IN RE: PETITIONS FOR SPECIAL HEARING AND ZONING VARIANCE - E/S Osler Drive, 550' N of Stevenson Lane 9th Election District 4th Councilmanic District

Case No. 89-137-SPHA

The Sisters of the 3rd Order of St. Francis, St. Joseph's Hosp.

FINDINGS OF FACT AND CONCLUSIONS OF LAW

L1

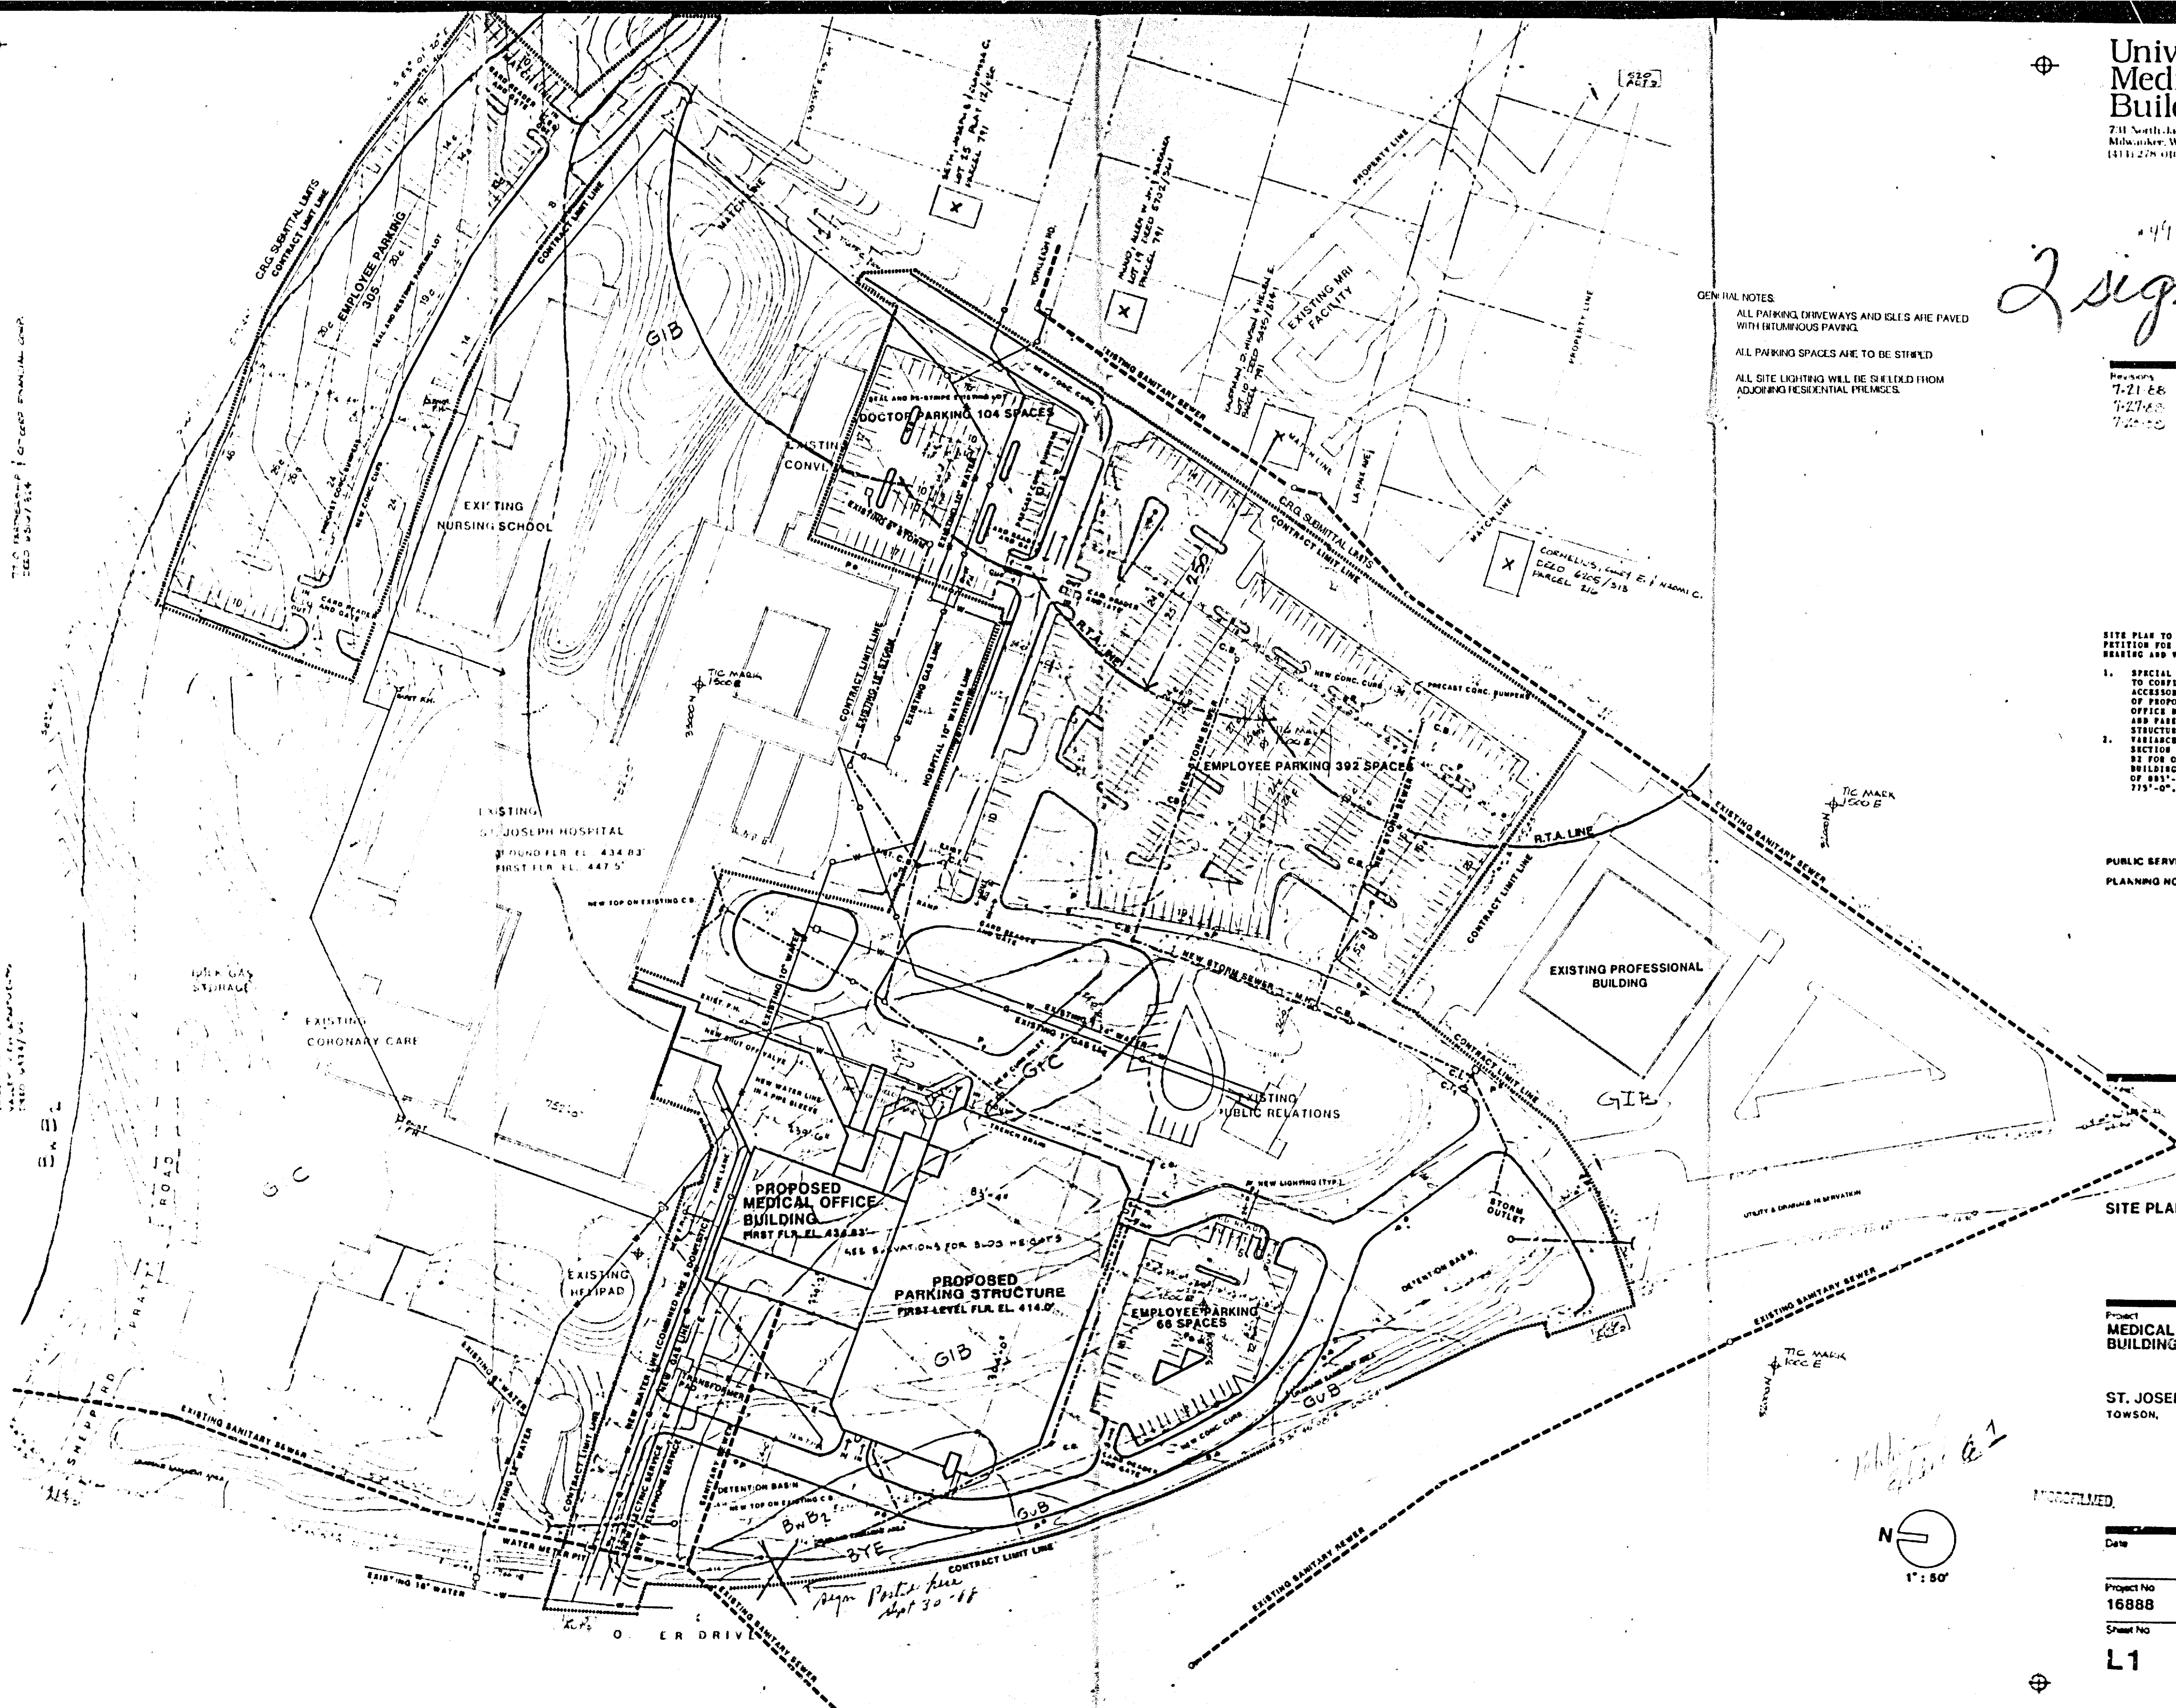
Show the R.T.A. arcs on the plan and clearly label, shade and dimension parking buffer and setbacks per S.1801.B (see attached R.T.A. paragraph). The R.T.A. arcs shown on the hearing petition plan on Exhibit 1, Sheet L-1 are incorrect and must be revised and new plans included in the case file #89-137-SPHA. Small car parking is permitted but at a 40% maximum of all spaces. Show the calculations supporting this figure for the entire hospital site.

4. R.T.A. - On a revised site plan (L-1) indicate compliance with the R.T.A. regulations on parking lots. The proposed parking lot is shown as a U.R.-2 zone. Show clearly all uses including dwellings within 300 ft. of the property lines. Indicate all property divisions and vacant lot acreages as they adjoin the subject property. Show all required R.T.A. arcs and note on the plan "All offsite dwellings and small lots of record (less than 2 acres) that create a R.T.A. onsite are shown with the required 300 ft. and 250 ft. arcs".

5. Parking - On the site plan L-1 or a revised overall plan, show detailed parking required calculations broken down by use - hospital core - 1/4 beds and medical offices 4.5/1,000 sq. ft. and retail 5/1,000 sq. ft. Parking provided should be broken down by - surface, parking structure, existing, proposed, building by floor, displacement during construction, and employee totals. Also, provision for meeting the required total for the existing facilities during construction that will displace the existing lots including the visitor parking. If phasing of construction will occur to minimize the displacement, the phasing and the totals for each phase should be compared with the required total.

8. Clearly show the extent of all existing parking lots within the Residential Transition Areas. All new parking areas and uses are subject to the R.T.A. restrictions. Clearly show the required R.T.A. Buffer area boundary, label the buffer areas and dimension the buffer areas, all of the above on the 1" = 50 ft. L-1 plan.

L4

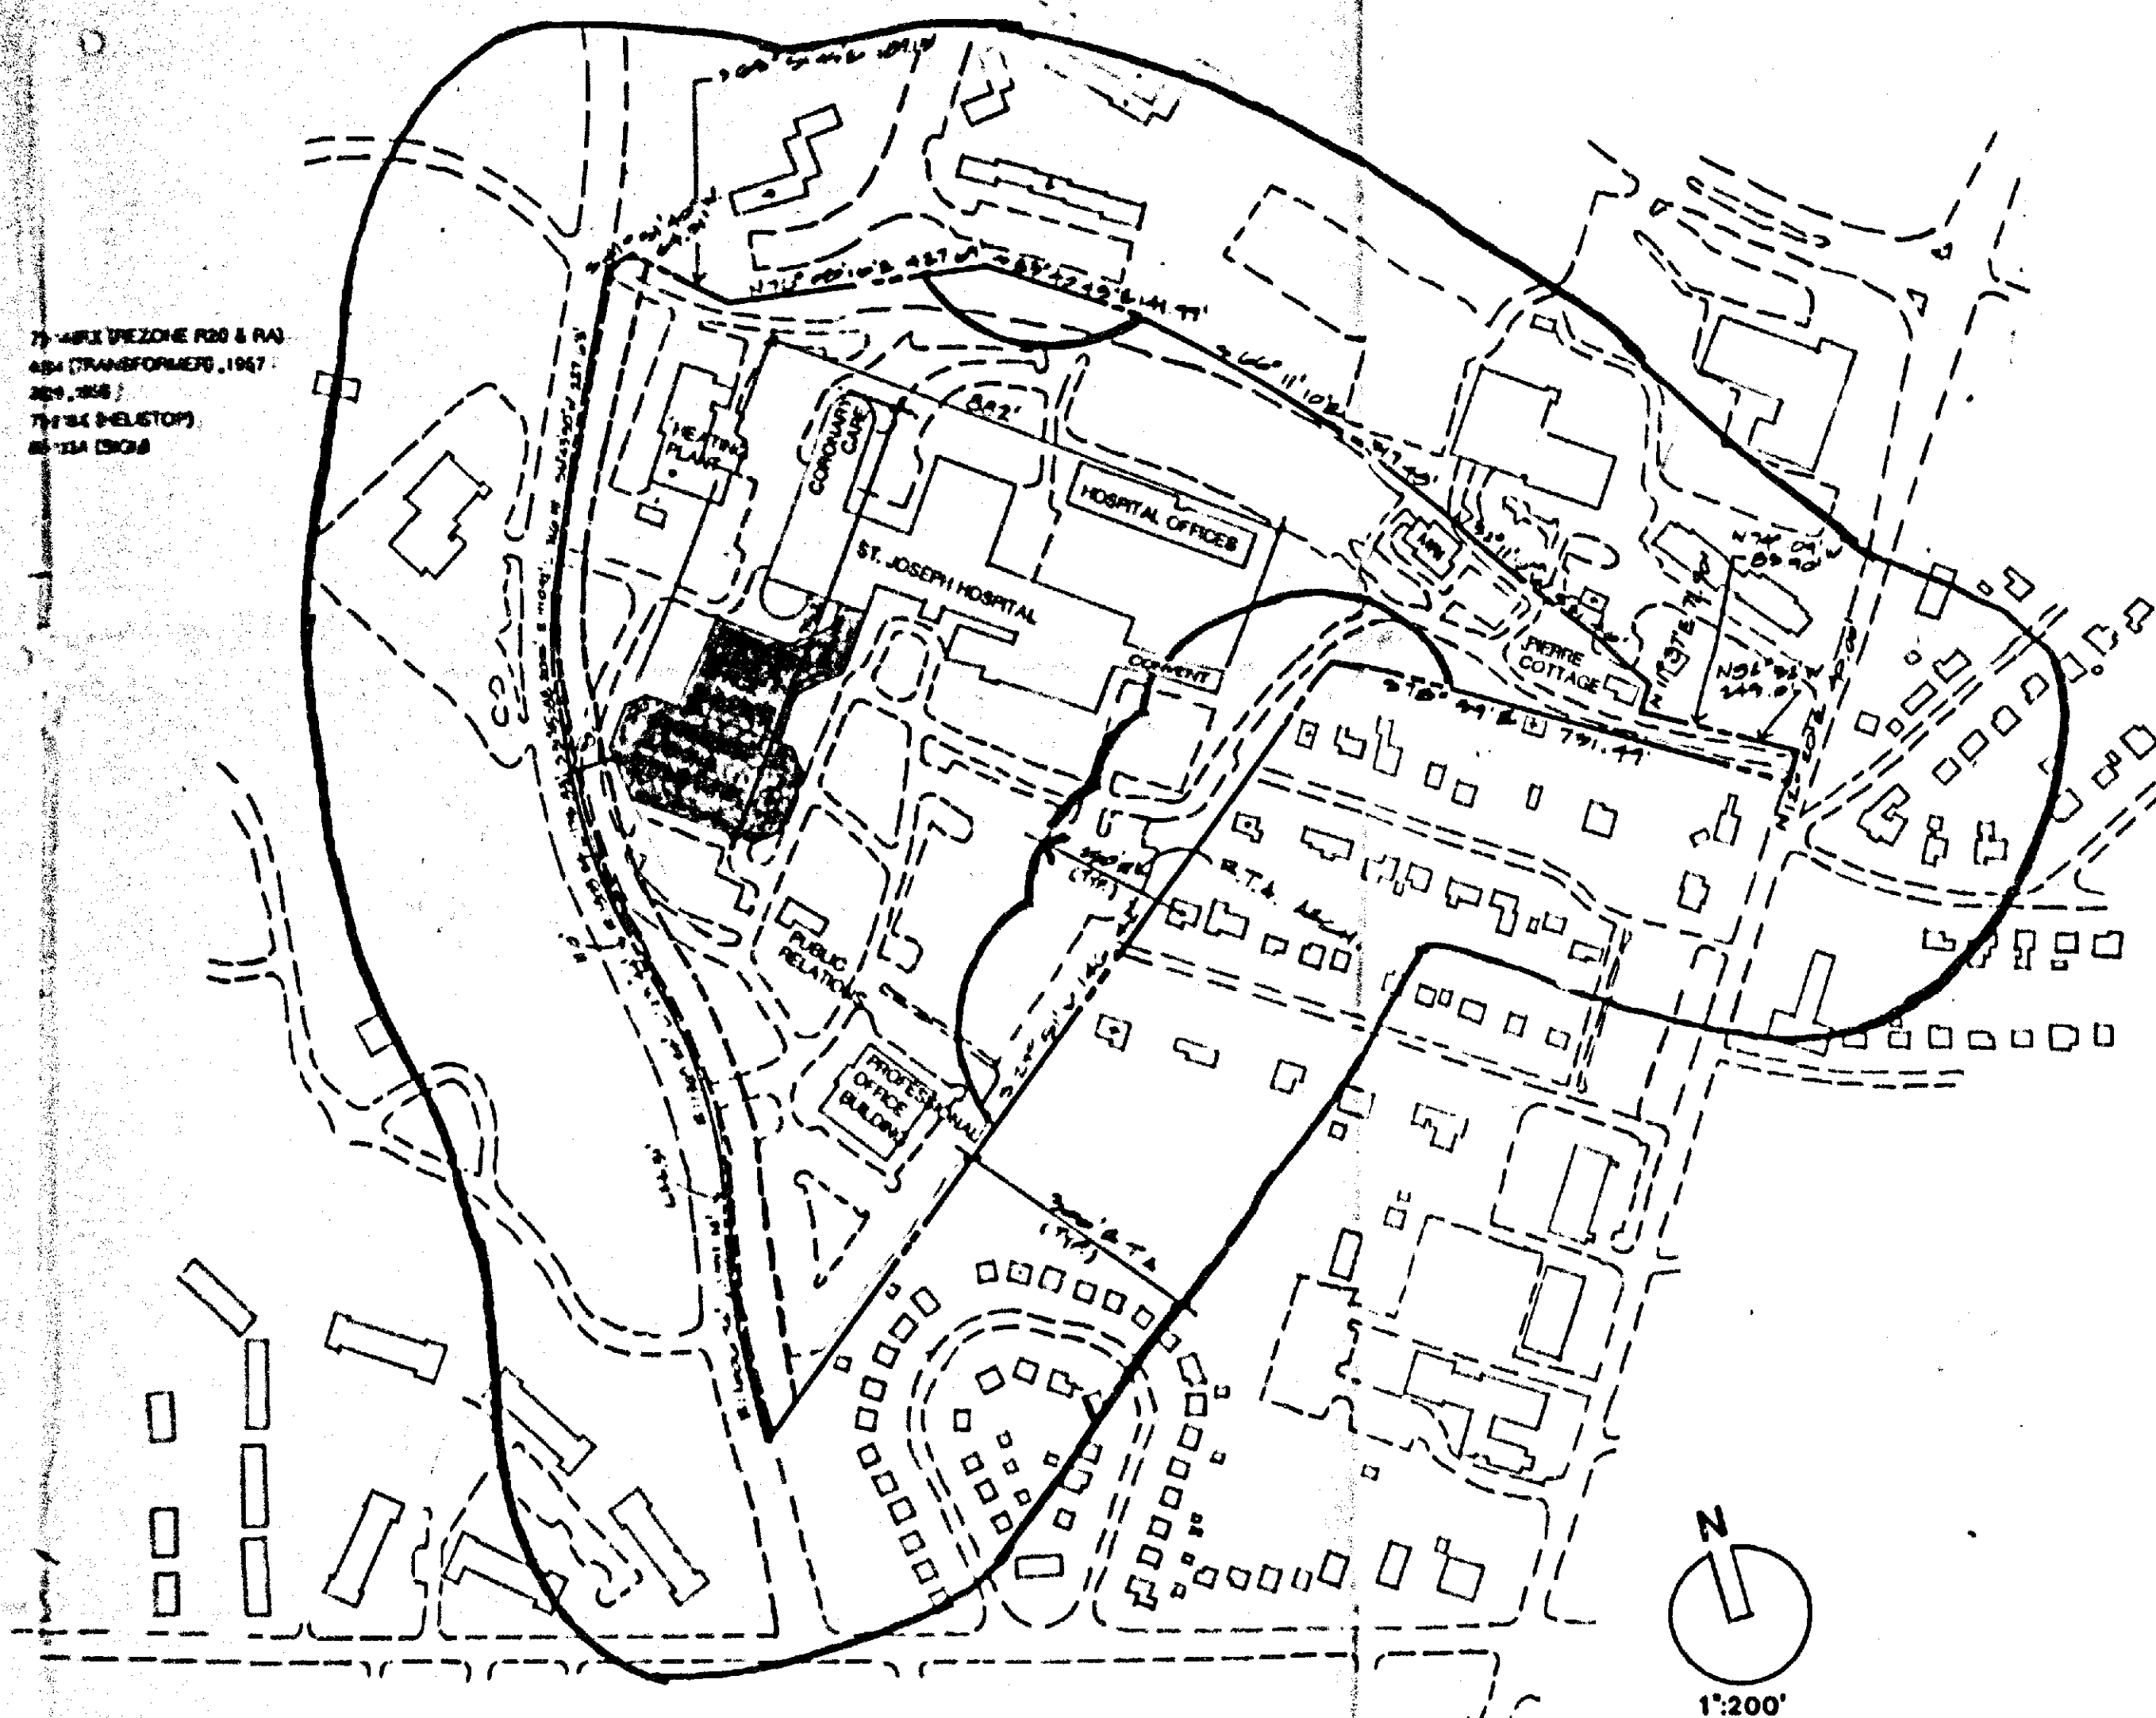
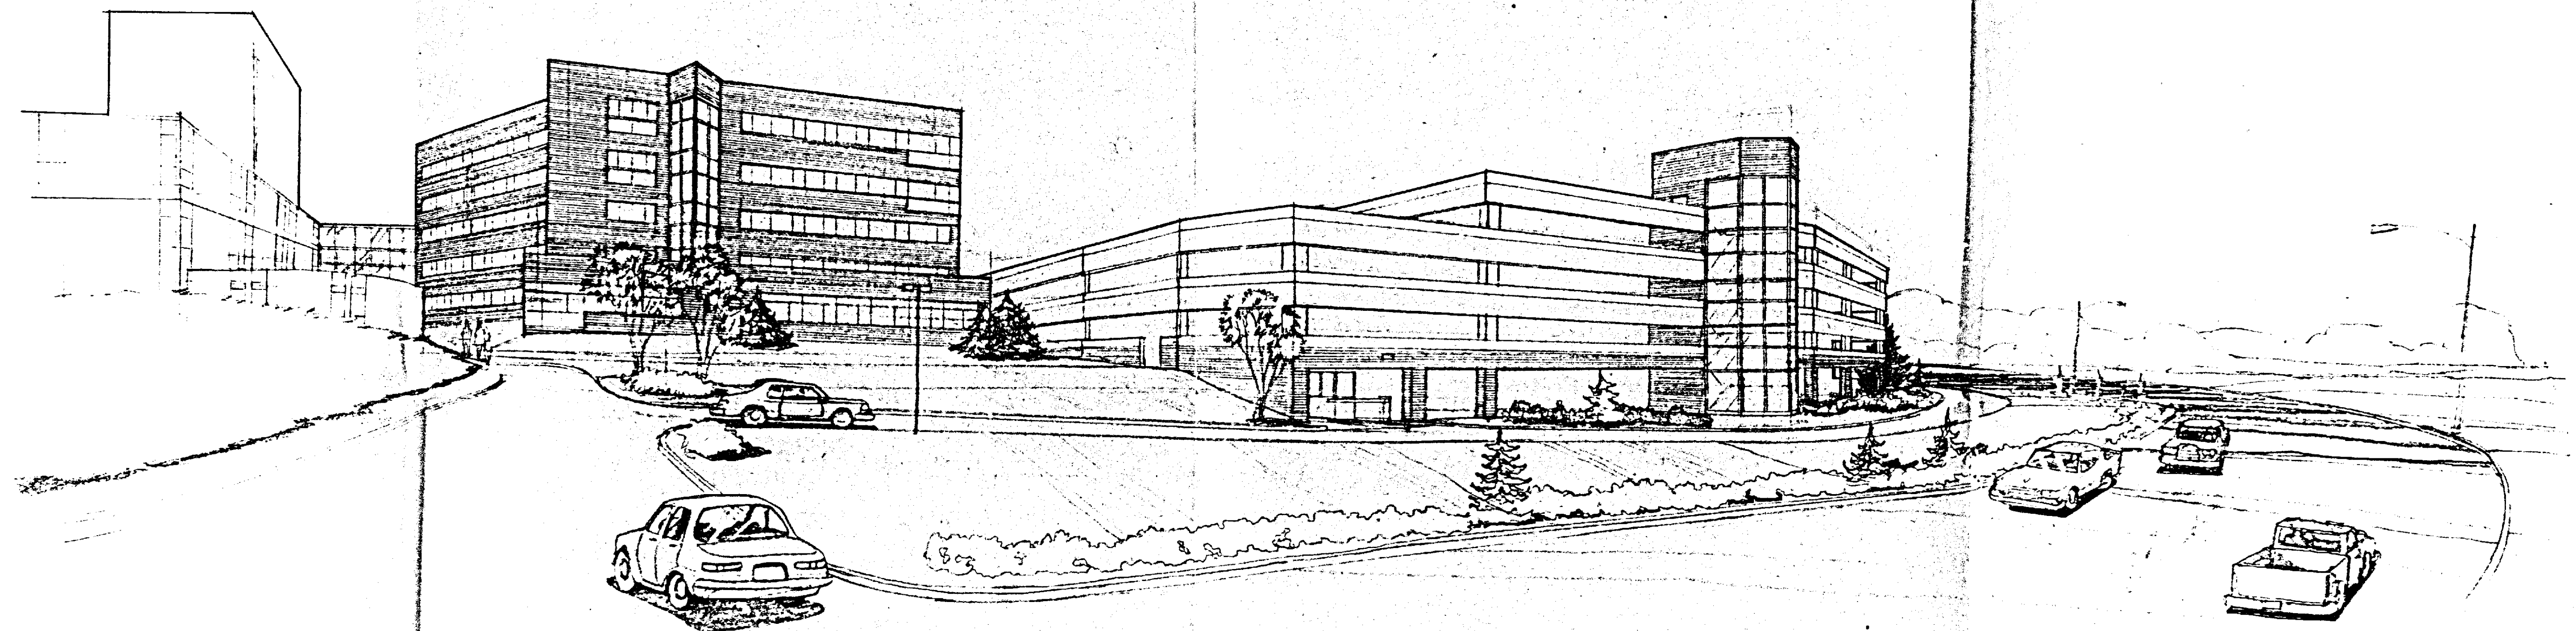
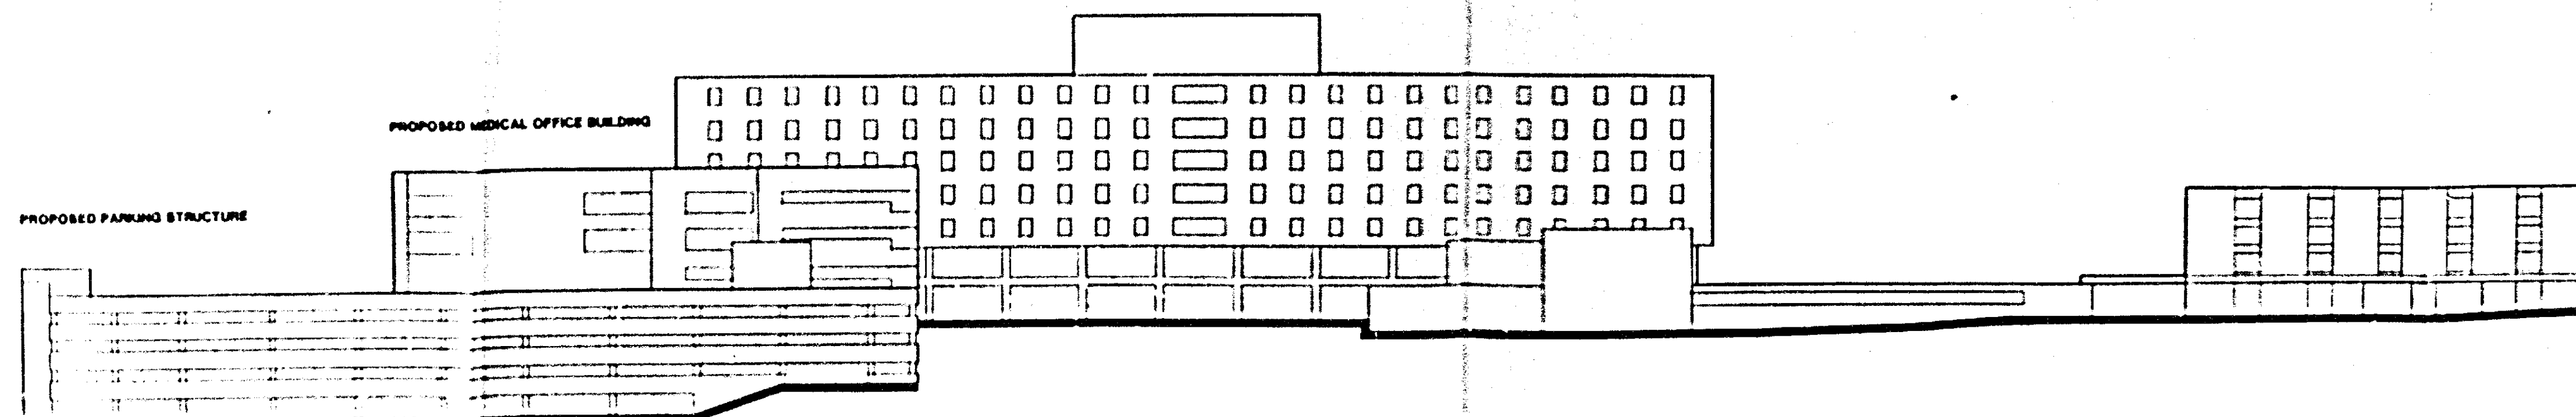
The reasons for the parking calculation requirement changes as red-lined are not clear. State on the plan why and how each change differs from the original plan; for example, on sheet L-4, the hospital at 460 beds is changed from 1/4 beds to 1.5/beds and the parking is changed from 115 spaces to 690. How? Why? Also, parking on sheet 1 must agree with the sheet 4 chart.
